CITY OF MERCER ISLAND

RE: Request for Information #2 for File No. SUB21-008 – Koneru Short Plat
6610 East Mercer Way, Mercer Island, WA 98040; King County Tax Parcel # 302405-9153

KONERU SHORT PLAT, SUB21-008

Re: Koneru Short Plat (SUB 21-008/CAO 22-003)
6610 East Mercer Way
Mercer Island, Washington

SITE MAP
SCALE: 1"=40'

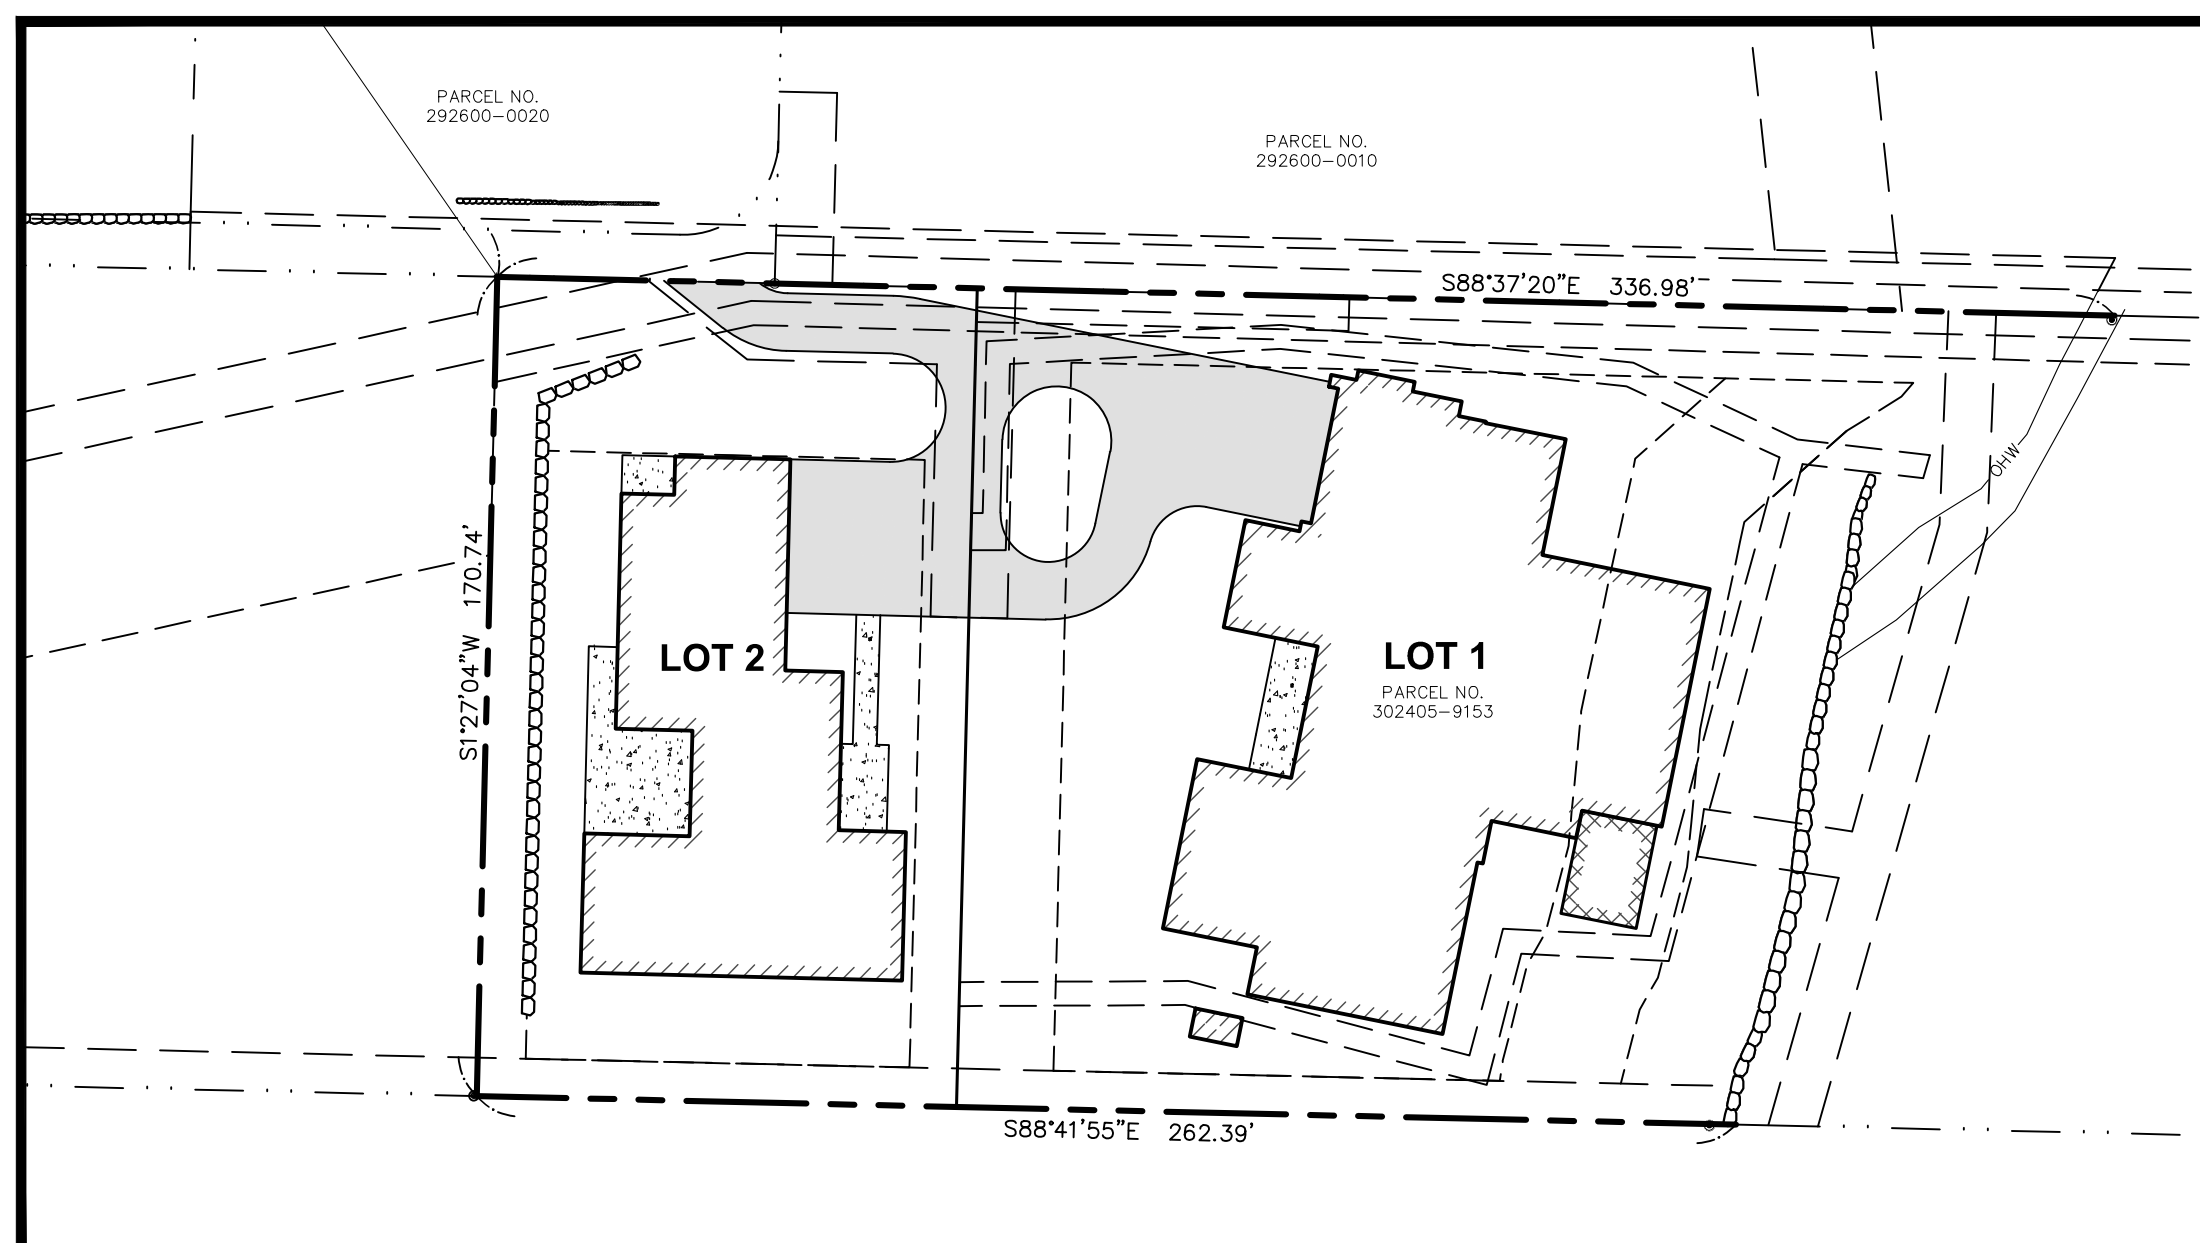
Therefore, we agree with the statement on the cover sheet of the plans. ***“This request does not guarantee that the lots will be suitable for development now or in the future.”***

PRELIMINARY SHORT PLAT

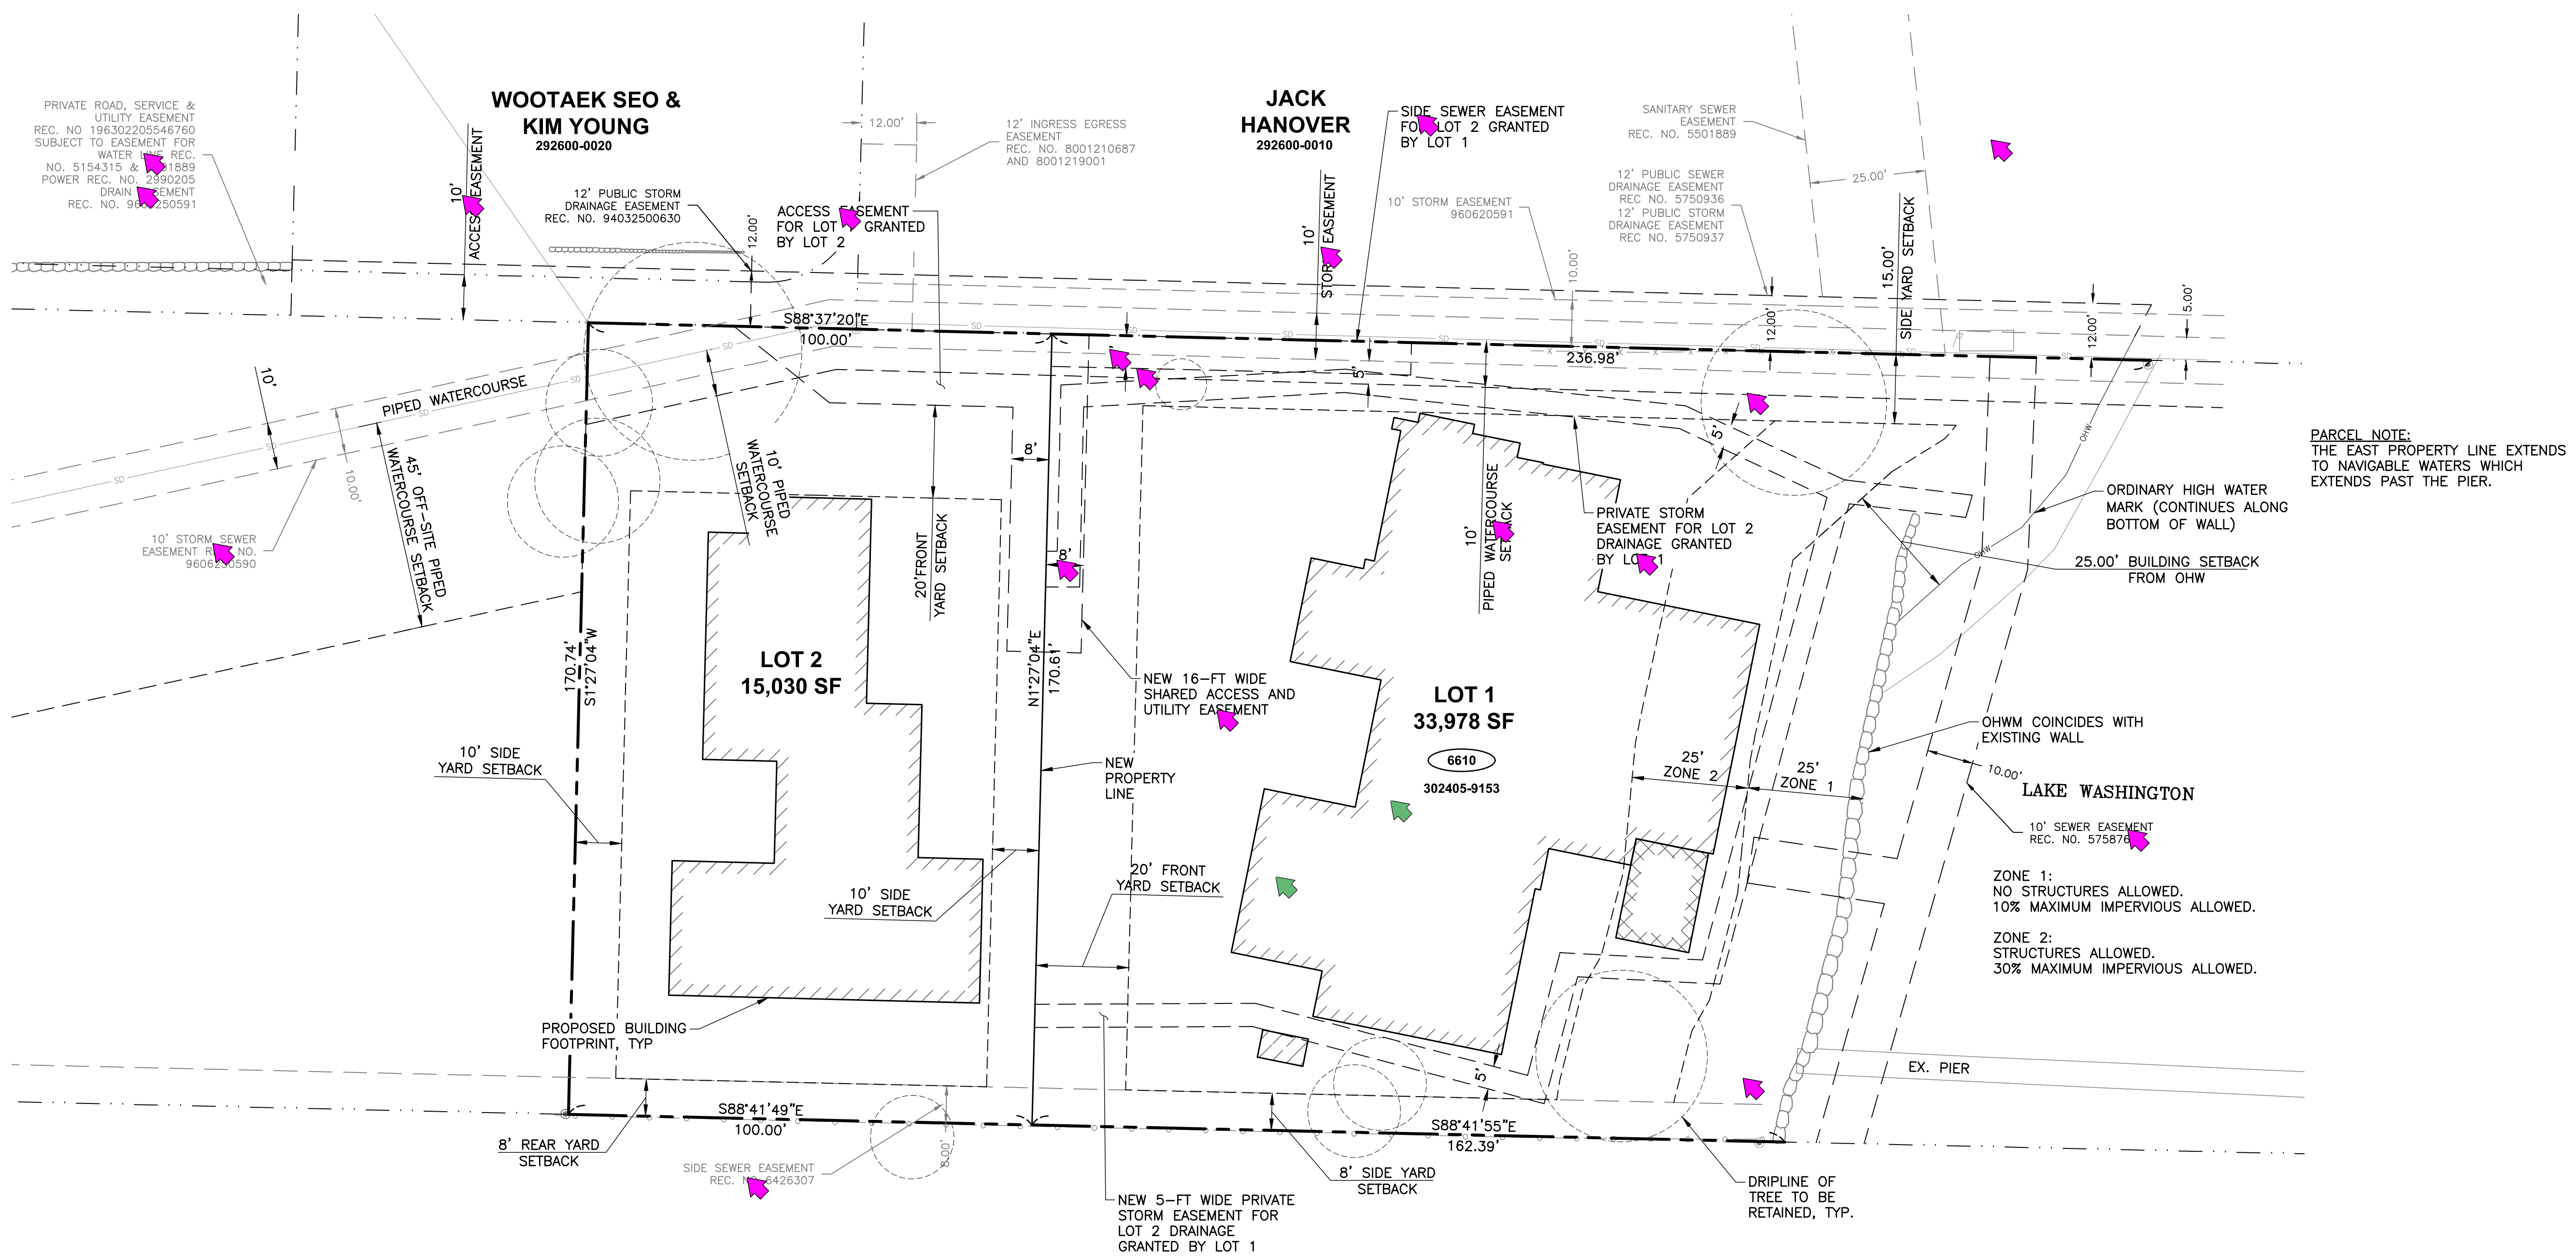
1. The plat map needs to have the statement from the fire marshals office placed on it.

“All building permits are subject to meeting current fire code requirements at the time of a complete submittal, including fire apparatus access as outlined in adopted code sections of the International Fire Code Appendix D. Fire plan reviews will be conducted at time of building permit submittal and may require additional fire protection systems /or additional fire prevention measures for building approval.”

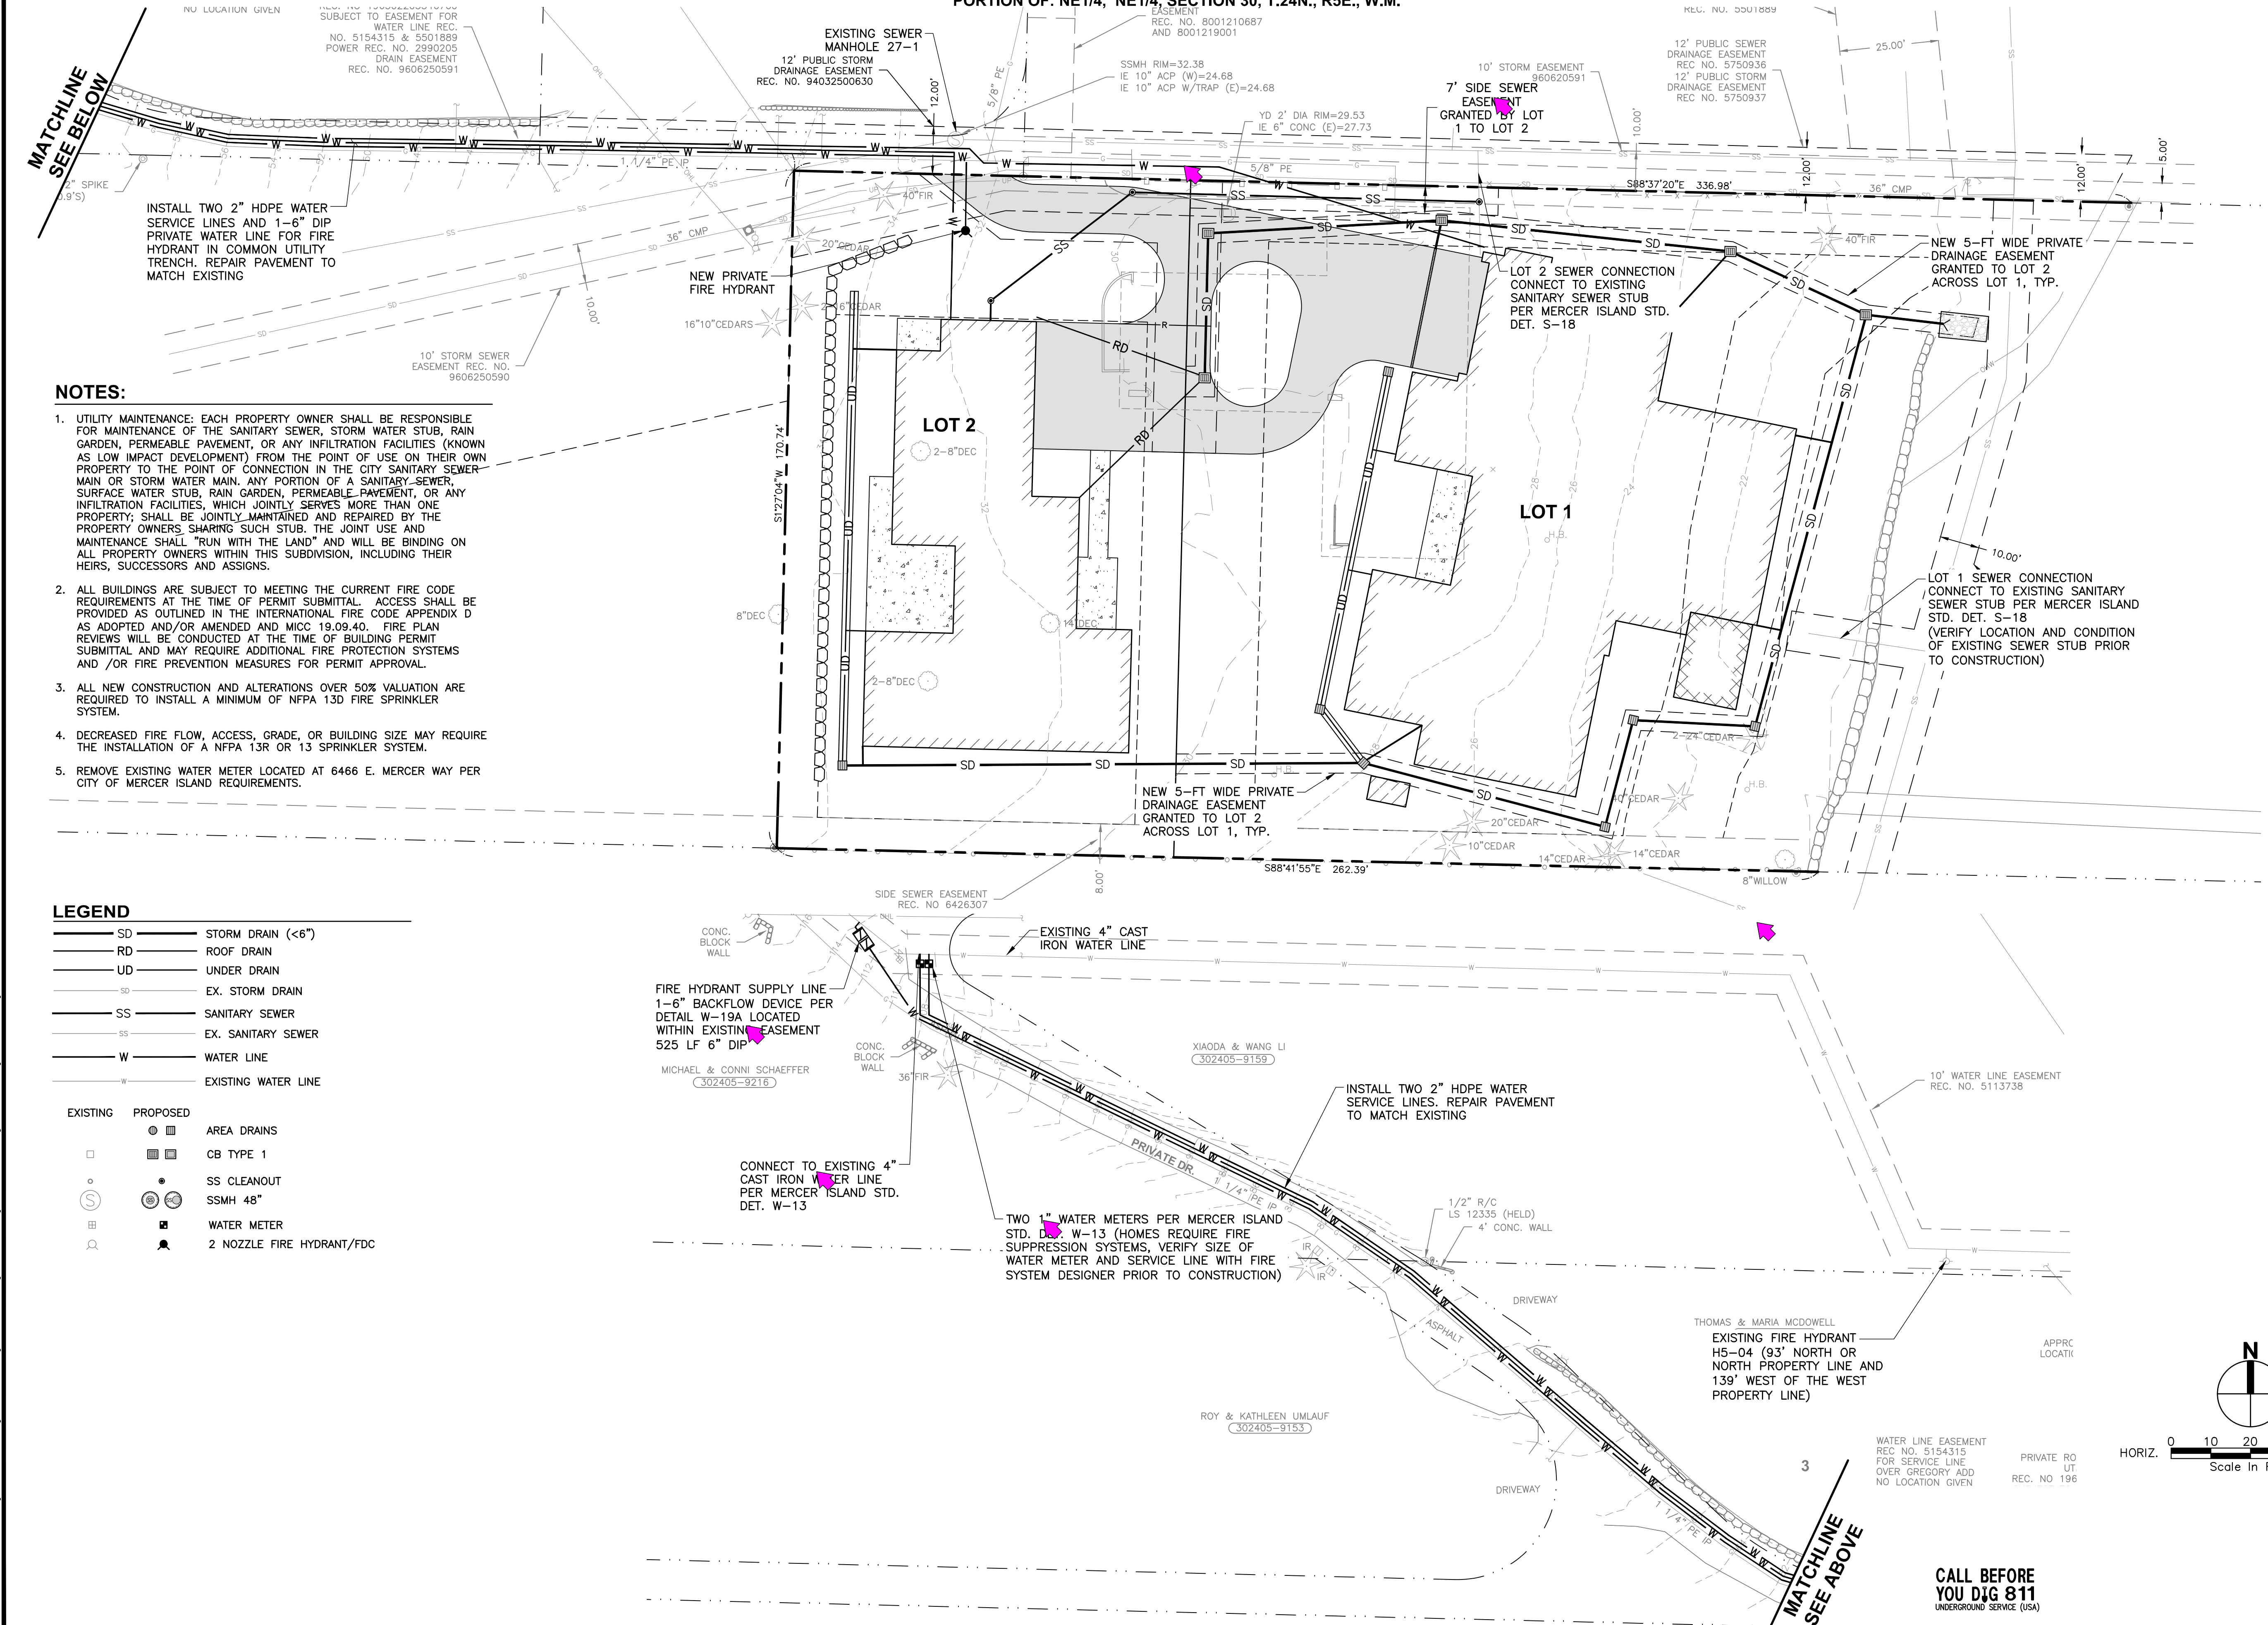
5. Future Building Permits:
 - a. For Civil and Arborist) During building plan review a tree protection plan with all Civil information must be created. Tree protection will need to be shown on C3.0. The retaining wall, trench, and other utilities to be moved outside saved trees driplines/minimum limits of allowable disturbance. The SD is shown within 9-feet of exceptional tree 576. Tree 575 also has a SD line within minimum limits of allowable disturbance. Update tree protection plan with tree protection chain link fence and all the following items in this checklist. Exceptional trees must be retained according to 19.10.060.3, and protected under 19.10.080.
